24 April 2023

**LETTER OF INTENT – A12 Chelmsford to A120 proposed scheme: Main Road, junction 21 and, walking cycling and horse-riding (WCH) overbridges**

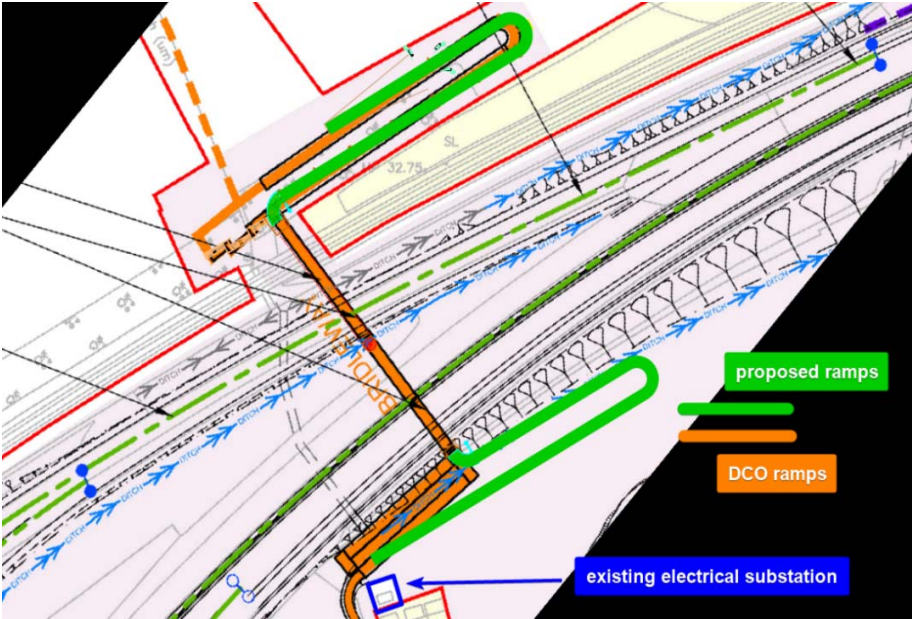
We have had several workshops where we have discussed the arrangements for the WCH overbridges. At Deadline 4, and as discussed on 28 March 2023, we submitted updated Streets, Rights of Way and Access plans (SRoWA plans) to include limits of deviation (LoD). The purpose of including the LoD on the SRoWA plans is to make it clear that the flexibility that exists for the Works Plans, i.e., constructing the works within the LoD (in accordance with the Order), also exists for the ultimate location of the WCH routes proposed by the A12 scheme. This reaffirms that at the locations where we are seeking to implement Essex County Council's request for 5-metre external radii we can do so, and it accords with the preliminary design.

Paynes Lane

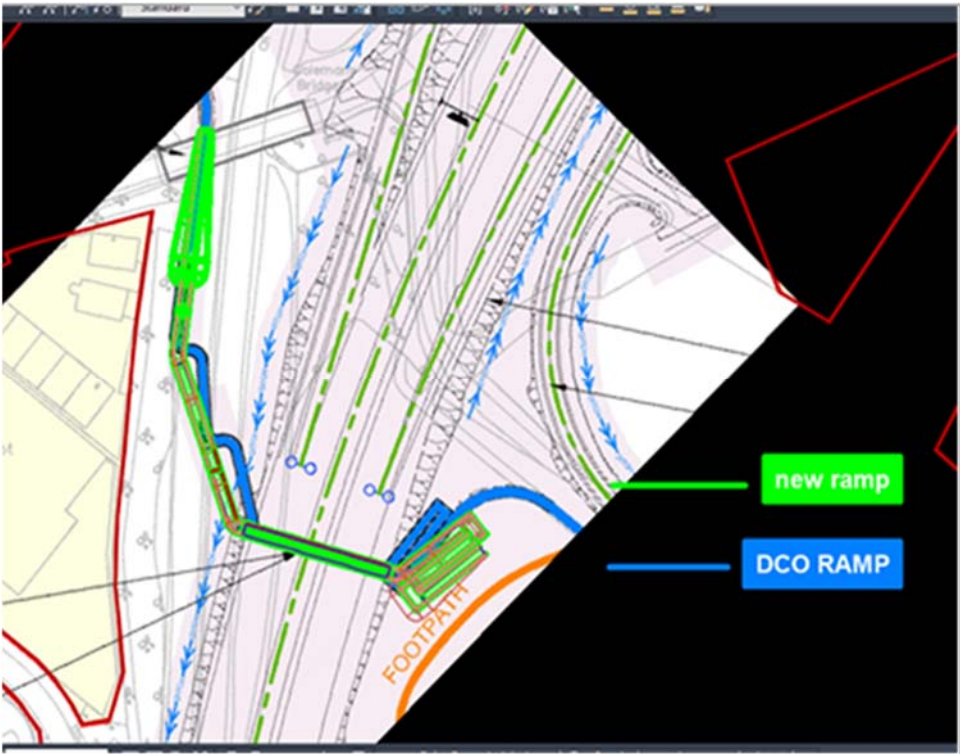
As shown in the design provided below, the A12 project team will, in detailed design, implement 4m internal radii on both the northern and southern ramps. We have also reduced the number of switchbacks on the southern ramp from two down to one.

It is important to note that proposed design on the southside does not accord with the preliminary design drawings submitted when the application was made. However, the project has assessed the environmental effects of the changes to the layout, in particular to the approach on the Main Road side of the A12, to ensure it does not give rise to any new or materially different environmental effects. That assessment has concluded that it does not give rise to new environmental effects and as such will be included in our detailed design submission to be consulted on with you and provided to the Secretary of State following the Development Consent Order being made. Subject

to Secretary of State approval, the proposed scheme would construct the bridges as per the revised configuration above.

Little Braxted

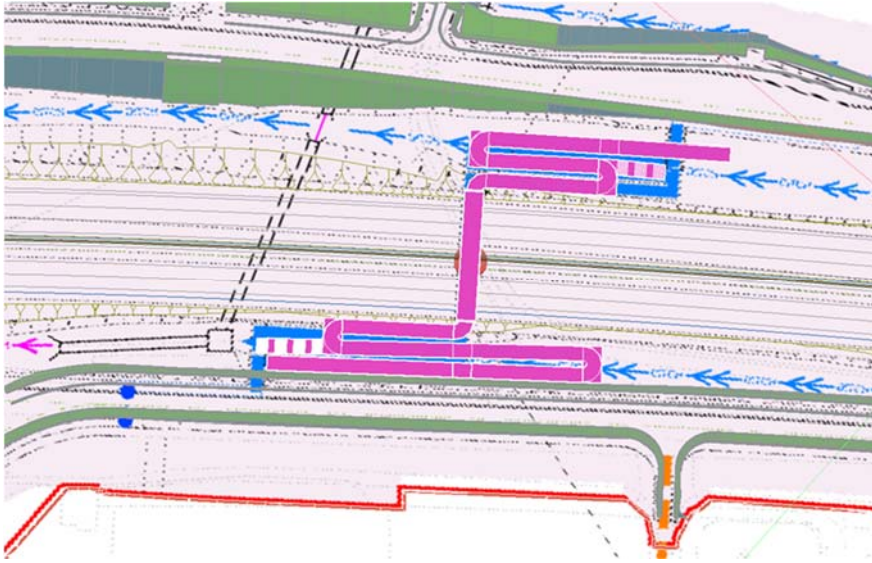
As you will be aware from our DCO submission, the A12 project team has straightened the northern ramp. As noted from the draft design below, we have further straightened the northern ramp and provided intermediate platforms. On the southern ramp we have developed a design that would provide 5 metre external radii. This can be seen in the drawing below. This design accords with the preliminary design.

### Potts Green

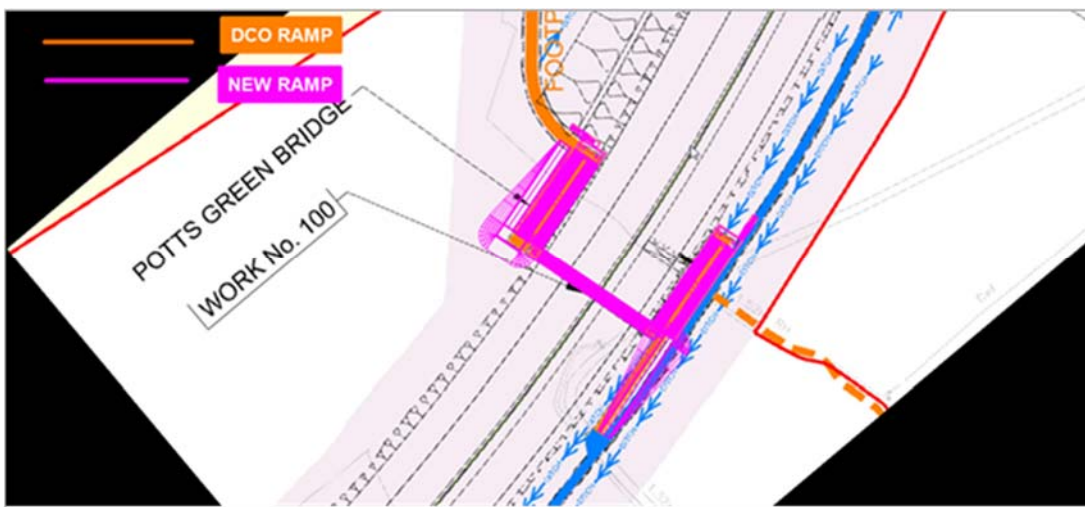
At this location we propose 5m external radii on both the northside and the southside as can be seen in the design below. This design accords with the preliminary design.
